Duke Energy Carolinas, LLC (Duke Energy)  
McGuire Nuclear Station (MNS), Units 1 and 2  
Docket Numbers 50-369, 50-370  
Renewed License Numbers NPF-9 and NPF-17

**Subject:** Response to August 28, 2014, NRC Request for Additional Information Regarding License Amendment Request to Implement a Risk-Informed Performance-Based Fire Protection Program (TAC Nos. MF2934 and MF2935).

**REQUEST FOR ADDITIONAL INFORMATION**  
**LICENSE AMENDMENT REQUEST TO ADOPT**  
**NATIONAL FIRE PROTECTION ASSOCIATION STANDARD 805**  
**PERFORMANCE BASED STANDARD FOR FIRE PROTECTION**  
**FOR LIGHT WATER REACTOR GENERATING PLANTS**  
**DUKE ENERGY CAROLINAS, LLC**  
**MCGUIRE NUCLEAR STATION UNITS 1 AND 2**  
**DOCKET NOS. 50-369, 50-370**

Figure FM-01.j(1)

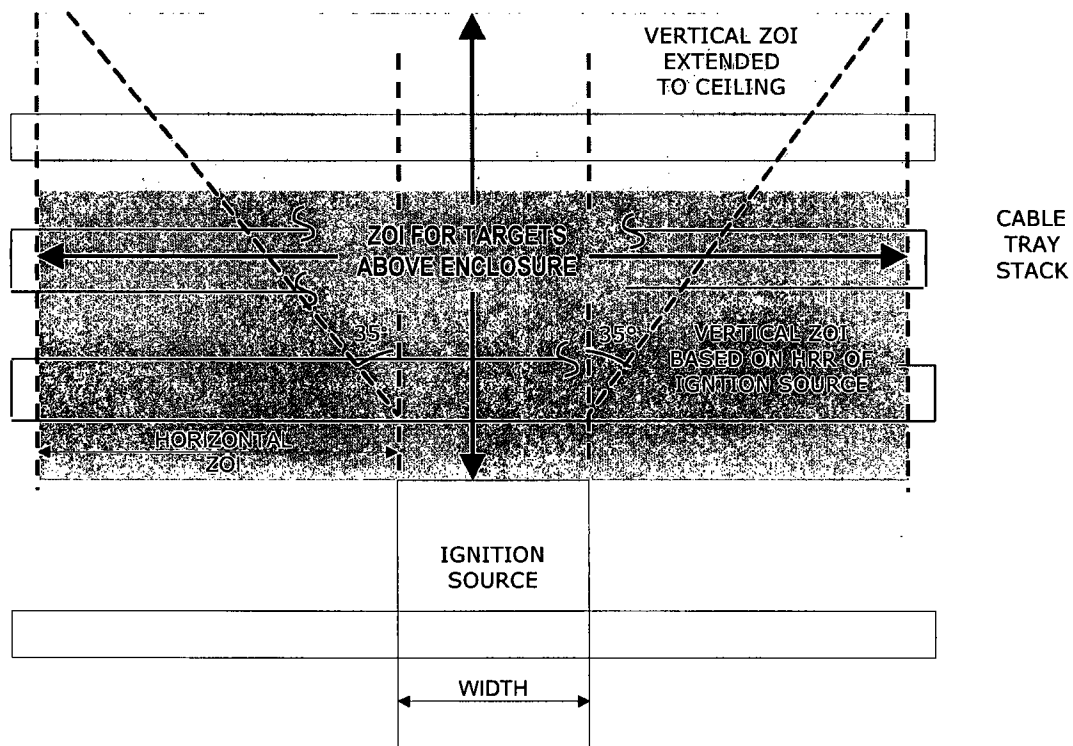
- j. Regarding the flame spread and fire propagation in cable trays:

Section V.2.3 of the LAR and the licensee's response to F&O FSS-C2-01 indicate that the licensee did not calculate fire propagation in, and the resulting HRR of, cable trays as described NUREG/CR-6850, Section R.4.2. The licensee's justification appears to be based on EIR 51-9160514-000, which as stated in the response to F&O FSS-C2-01, "... suggests that armored cables will not contribute to fire growth and spread ..." (see LAR, Attachment V, page V-8).

1. During the audit the NRC staff reviewed the summary in EIR 51-9160514-000 of selected results of a test program conducted by the licensee, and determined on the basis of this summary that the horizontal flame spread rate over armored cable with a PVC jacket in the test was between 0.5 and 2.2 mm/s.
2. During the audit plant walkdowns the NRC staff noticed several trays in different areas of the plant that appeared to contain some unarmored cable (for example, tray 3972 in Fire Area 13). The NRC staff notes that for thermoplastic and thermoset cables NUREG/CR-6850, Section R.4.1.2 recommends a flame spread rate of 0.9 mm/s or 0.3 mm/s, respectively.

3. During the audit the NRC staff reviewed the licensee's Design Basis Specification for Fire Protection and noted that 45% of the combustible mass of armored power cable, and 60% of the combustible mass of armored control cable is outside the armor. The contribution to the HRR from the PVC jacket around the armor is therefore expected to be not negligible.
4. FAQ 08-0049 provides guidance on calculation of cable tray ignition, fire propagation between cable trays, and HRR. The FAQ indicates that the licensee will need to develop and justify plant-specific, configuration-specific models if they are to be used outside the original ZOI, and that these models will be an area of detailed staff review.

In light of these observations the analysis should account for the impact of the horizontal flame spread, vertical fire propagation and the resulting additional HRR on the ZOI and HGL temperature timing determination for fires that involve cables. Provide a summary of this re-evaluation, including the impact on the risk and delta risk.

- j. As described in the Fire Scenario Report, Section 9.2, the MNS Fire PRA (FPRA) adequately accounts for fire propagation by applying a ZOI that identifies targets that would be damaged due to flame spread (i.e., horizontal progression of flame along a cable tray) and fire propagation (i.e., vertical progression of fire to additional cable trays). The horizontal ZOI used in the MNS FPRA exceeds the fire's "characteristic length," as described in NUREG/CR-6850, Section R.4.2, in order to account for flame spread. The vertical ZOI used in the MNS FPRA is extended to the ceiling, in order to account for fire propagation. This is reflected in Fire Scenario Report Figure 9-1, which shows how the horizontal ZOI encompasses the 35 degree angle discussed in NUREG/CR-6850, Section R.4.2, and depicted in NUREG/CR-6850 Figure R-5. Thus, the MNS FPRA methodology adequately incorporates fire propagation and flame spread in cable trays, as described in NUREG/CR-6850, Section R.4.2. This is depicted in Figure FM-01.j(1) below:

The intention of the response to F&O FSS-C2-01 is to indicate that the approach taken in the MNS FPRA is adequate, because the armored cables predominately used at MNS are not expected to contribute to fire growth and spread. However, no actual credit is given for cable armor within the FPRA.

1. Regarding the horizontal flame spread rate of armored cable with a PVC jacket observed during tests that were evaluated in EIR 51-9160514-000, Duke Energy does not dispute the Staff's observation. As explained above, and as reflected in the Fire Scenario Report, Section 9.2, horizontal flame spread is adequately captured within the target set (i.e., the ZOI) of each scenario.
